**City of Portland, Maine - Building or Use Permit Application**  
 389 Congress Street, 04101 Tel: (207) 874-8703, Fax: (207) 874-8716

BUILDING PERMIT REPORT

DATE: 11 July 2001 ADDRESS: 161 Cumberland Ave. CBL 022-J-025

REASON FOR PERMIT: To install stairs for second means of egress.

# STAIRS TO BE BUILT AT 161 CUMBERLAND AVE. PORTLAND, ME

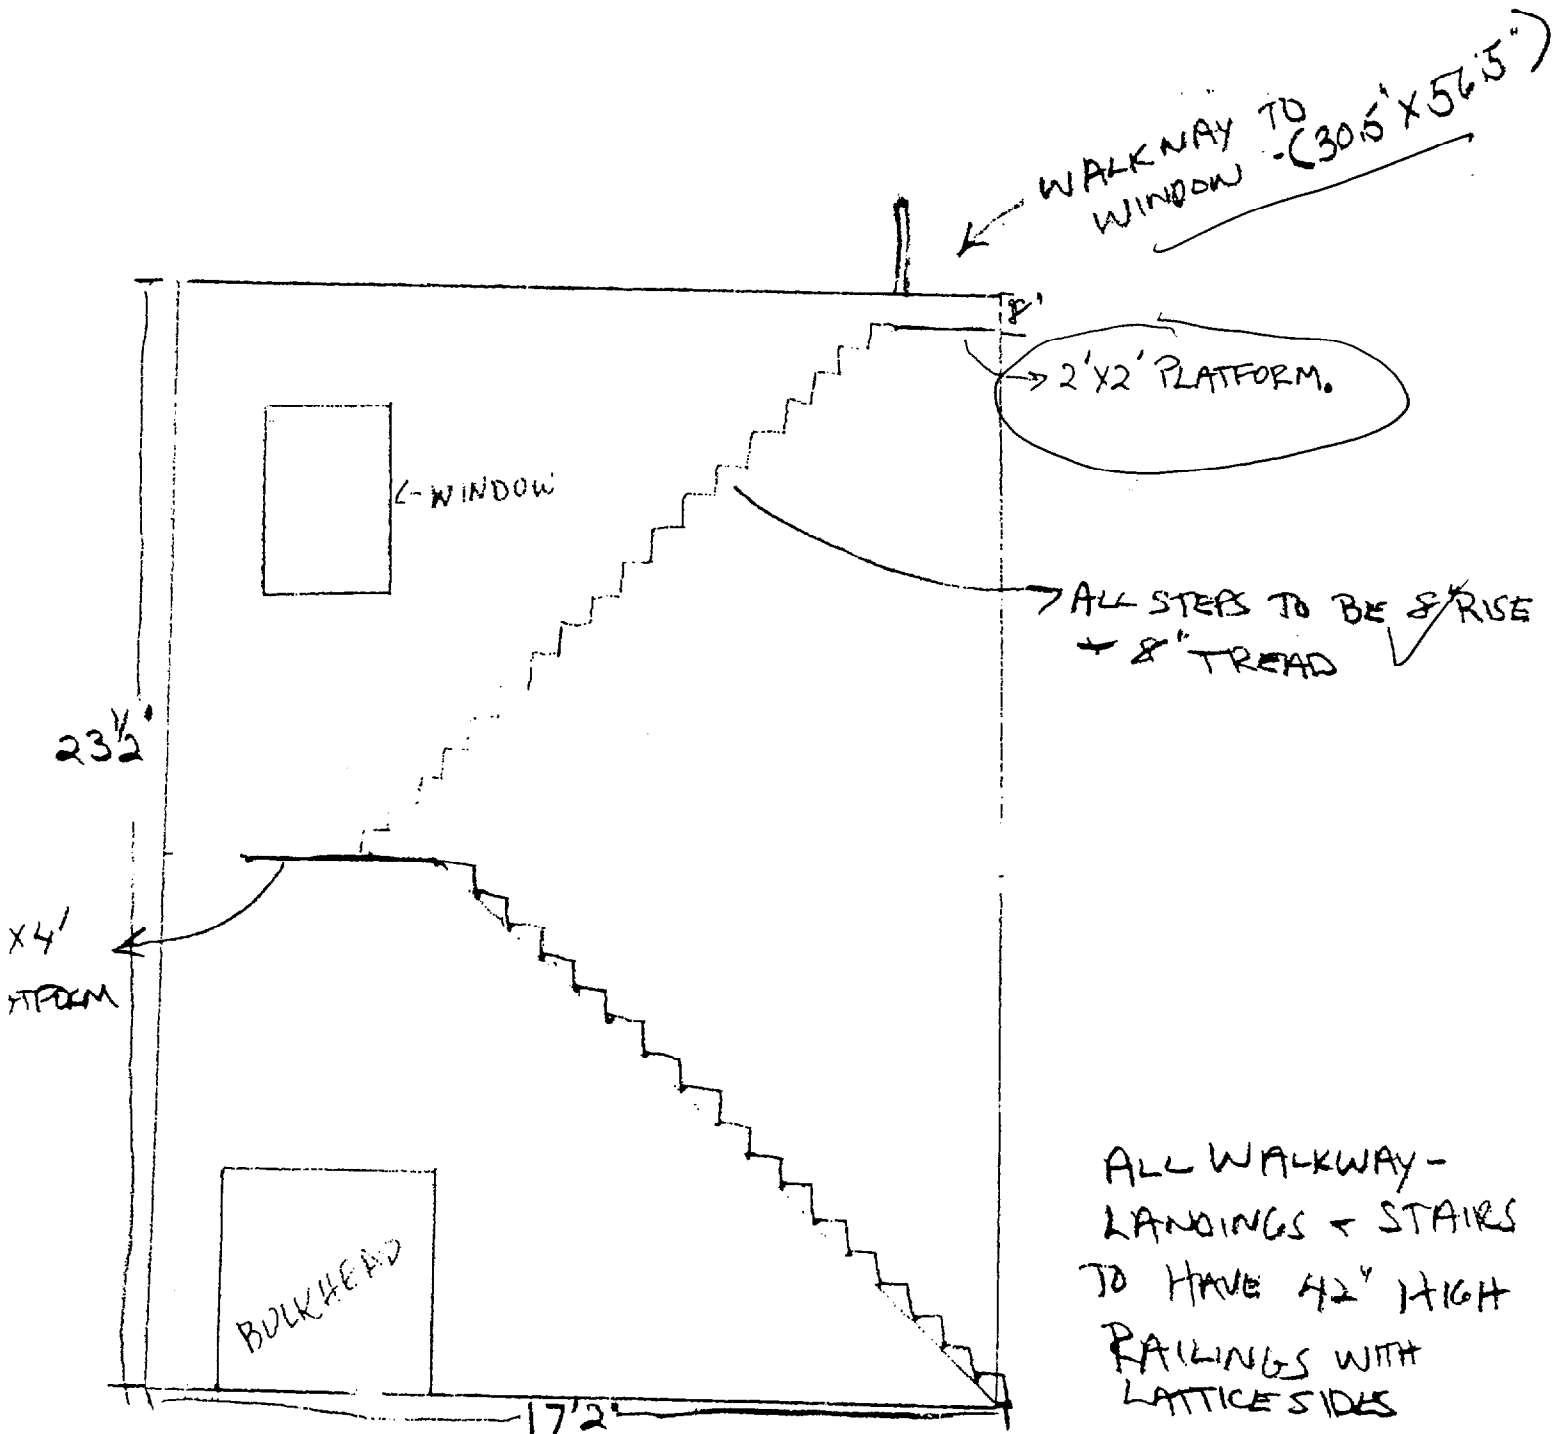
37. All signage shall be done in accordance with Section 3102.0 signs of the City's Building Code. (The BOCA National Building Code/1999).
- \*38. *This permit is being issued with the understanding that exterior stair can not be constructed as per section 1025.1.3 of the building code. (see attached)*

- \*39. *All requirements of section 1025.0 fire escape shall be followed. (see attached)*

*Per item #11, Guardrails and Handrails, Guardrail will be 42" high and 3 1/2" wide with 1x2 protective lattis work. Handrails will be 36" high on both sides of stairs with 1 1/2" grip on building side, 3 1/2" protective rail on outside. 4x4" pt newels with 1x2 lattis work with no more than 4" spacings.*

*Per item #36, platform will be built and supported off the building as not to obstruct walkway.*

*Per item #37, framing and fastning will be done in accordance with all applicable codes. 2x8 pressure treated joist to create landings not smaller than 42"x48"; 5/4x6" pt decking platform surfaces. 4x6" pt bracing to run from deck to wall. 4x6" pt bracing will be carriage bolted to the deck with 1/2" galvanized carriage bolts and bolted to the wall with 1/2" galvanized lags. 2/12pt stringers with 24x93/4x1" metal teads as specified by building inspector. Stairs will be bolted to stringers with 1/2" galvanized lags. All galvanized nails and fastners will be as specified by code. Drawing to followed:*

STAIR STRINGERS SHALL BE CUT FROM 2X12 STOCK  
 Treads to be steel 9 3/4" w, 1 inch thick, 24" long

DETAILS FOR STAIRS AT 161 CUMBERLAND AVE PORTLAND, ME

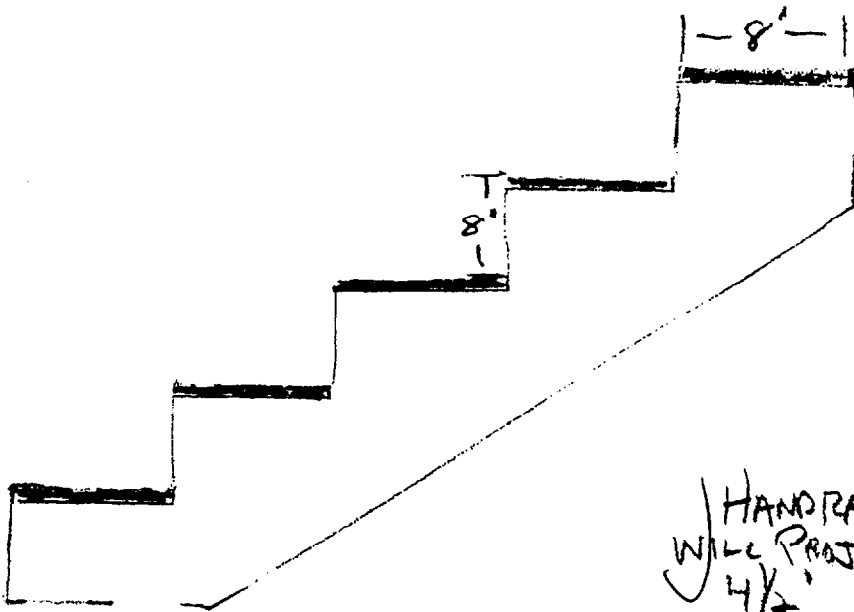
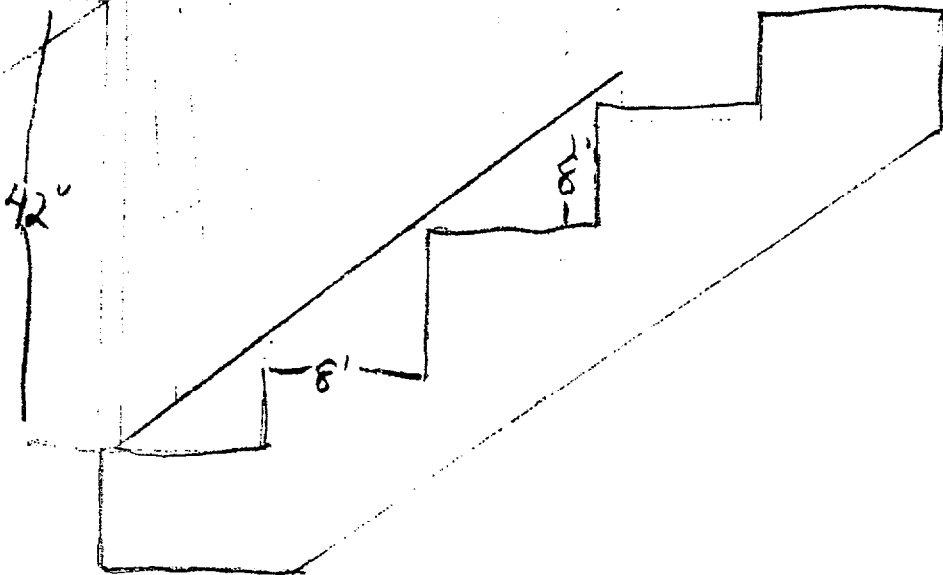
10. Sound transmission control in residential building shall be done in accordance with Chapter 12, Section 1214.0 of the City's Building Code.
- \* 11. Guardrails & Handrails: A guardrail system is a system of building components located near the open sides of elevated walking surfaces for the purpose of minimizing the possibility of an accidental fall from the walking surface to the lower level. Minimum height all Use Groups 42". In occupancies in Use Group A, B, H-4, I-1, I-2, M, R, public garages and open parking structures, open guards shall have balusters or be of solid material such that a sphere with a diameter of 4" cannot pass through any opening. Guards shall not have an ornamental pattern that would provide a ladder effect. Handrails shall be a minimum of 34" but not more than 38". Exception: Handrails that form part of a guard shall have a height not less than 36 inches (914 mm) and not more than 42 inches (1067 mm). Handrail grip size shall have a circular cross section with an outside diameter of at least 1 1/4" and not greater than 2". (Sections 1021 & 1022.0). Handrails shall be on both sides of stairway. (Section 1014.7) **R-3 (ONE & TWO FAMILY DWELLINGS) GUARD HEIGHT IS 36" MINIMUM.**

HANDRAILS WILL PROJECT 4 1/2"

HANDRAIL GRIP SIZE WILL BE 1 1/2" ON BUILDING SIDE & 3 1/2" ON OPEN SIDE
